**RE:** Old Mill Elementary School - Additional Site Work **DC**

## Old Mill Elementary School April 3, 2024

## Request for Proposal – March 7, 2024 – To: Trademark/Willet

**A** ELEMENTARY PLAYGROUND ENLARGEMENT  
SCALE: 1"=10'

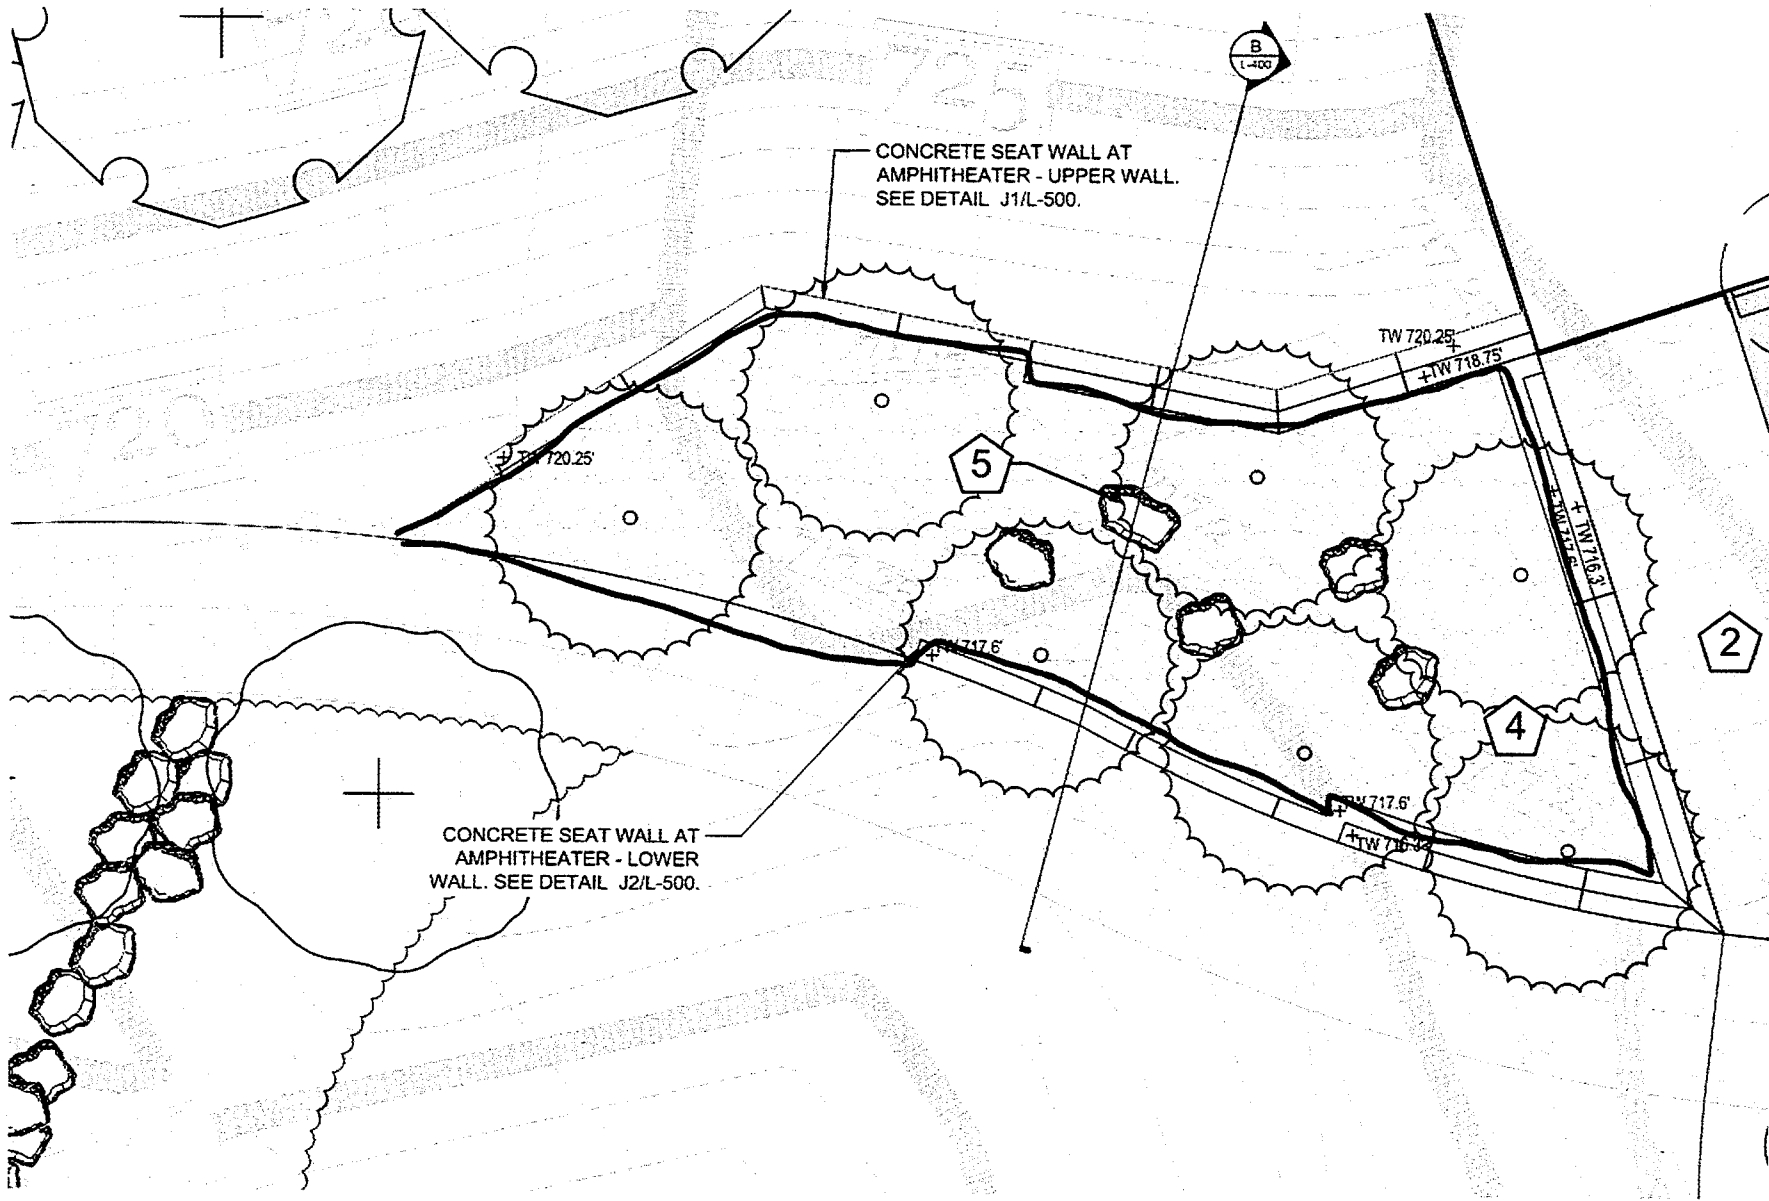
4. Remove limestone gravel/aggregate and landscape fabric from amphitheater/playground area. Aerate and scarify subgrade, add approximately 6" topsoil (35cy) and place 200sy of turf-type tall fescue sod. Provide mulch tree rings around trees per landscape details. Use caution when excavating around trees.

### Item 4 – Sod at Amphitheater
